APICAL INDUSTRIES, INC.
dba DART AEROSPACE

ENGINEERING CHANGE NOTICE NO.

05110

DWG TITLE: STRUT ASSY

APICAL INDUSTRIES	2608 TEMPLE HEIGHTS DR.	OCEANSIDE, CA. 92056-3512	(760) 724-5300
STRUT ASSY			
REV. A	DATE CODE	DWG. NO.	647.7700
SCALE: NONE			
SHEET 1 OF 2

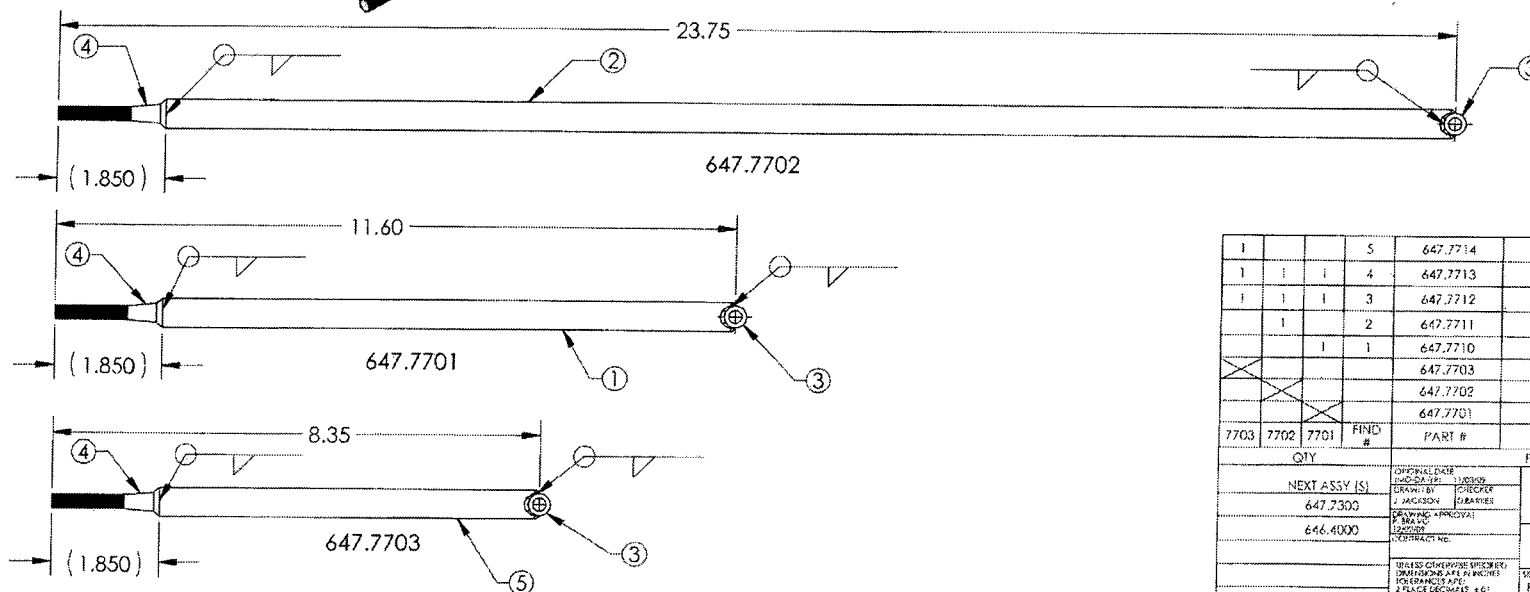
REASON: REVISED FINISH CALLOUT AS PER ECR 15-209

SHEET 1, NOTES IS:

- 1 MATERIAL: 4130 STEEL PER AMS-T-6736, .50" OD, .083" WALL THK.
- 2 MATERIAL: 4130 STEEL PER AMS-T-6736, .375" OD, .075" WALL THK.
- 3 MATERIAL: 4130 STEEL PER AMS-T-6736, .324" OD.
- 4 FINISH: PRIME IAW MIL-P-2337J TYPE I CLASS N; 1-2 MIL MAX
5. DEBURR AND BREAK ALL SHARP EDGES
6. IDENTIFY IAW MPP-120.
- 7 WELD IAW MIL-STD-2219. TIG WELD WITH FILLER ROD
- 8 FINISH: CAD PLATE IAW QQ-P-416F CLASS I TYPE II
- 9 MASK THREAD PRIOR TO FINISH
